Subject: RATTLE NOISE FROM REAR END OF PANORAMA SUNROOF WHILE DRIVING	Bulletin No.: 09-045/24
	Last Issued : 10/15/2024

2024 CX-90 (with Panorama Sunroof) with VINS lower than JM3KK*****176818 (produced before May 18, 2024)

2025 CX-70 (with Panorama Sunroof) with VINS lower than JM3KJ*****110175 (produced before May 18, 2024)

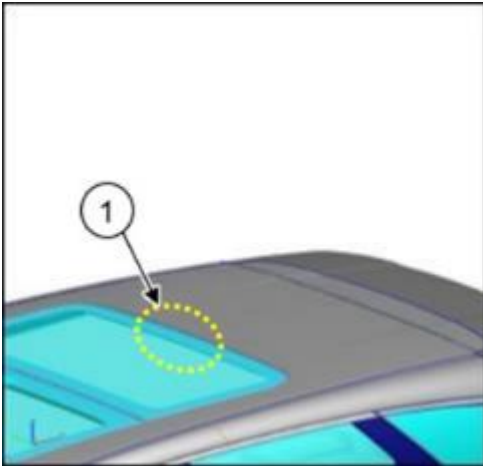
Some vehicles may exhibit a rattle noise from the rear end of the rear glass panel on the panorama sunroof. This may be caused by body vibration while driving and slight gaps (1) between the fastener mounting to the headliner and the sunroof frame. To eliminate this concern, the fastener has been modified to restrain the rattling.

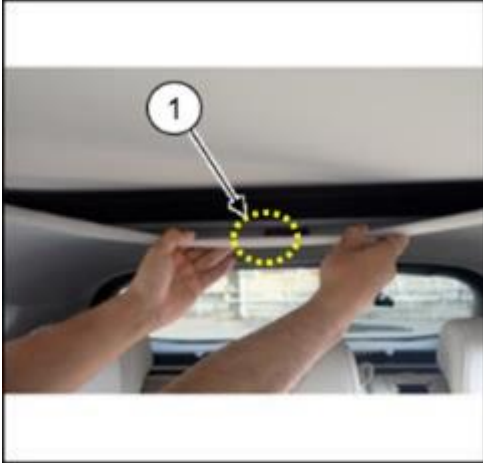
1. Verify the customer concern.
2. Replace the fastener mounting to the headliner with the modified one according to the following procedures.
 - a. Insert fingers into the gap between the rear edge of the headliner and the rear end of the sunshade, then pull down the headliner to access the fastener (1).

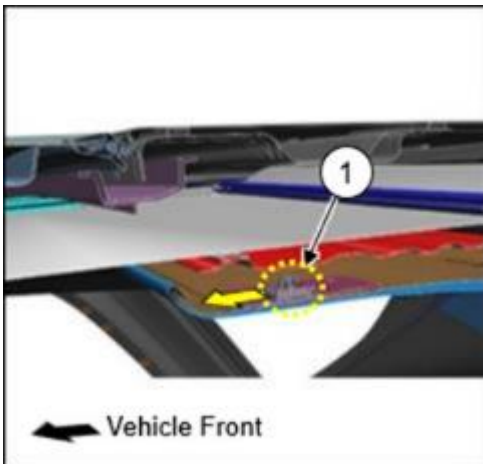
- b. Insert hand into the gap and remove the fastener (1) while sliding it to the vehicle front.
ATTENTION: Be careful not to damage or stain the headliner.

- c. Install the modified fastener in the reverse order of the removal.
 - d. Put the headliner back in the original position.
3. Verify the repair.
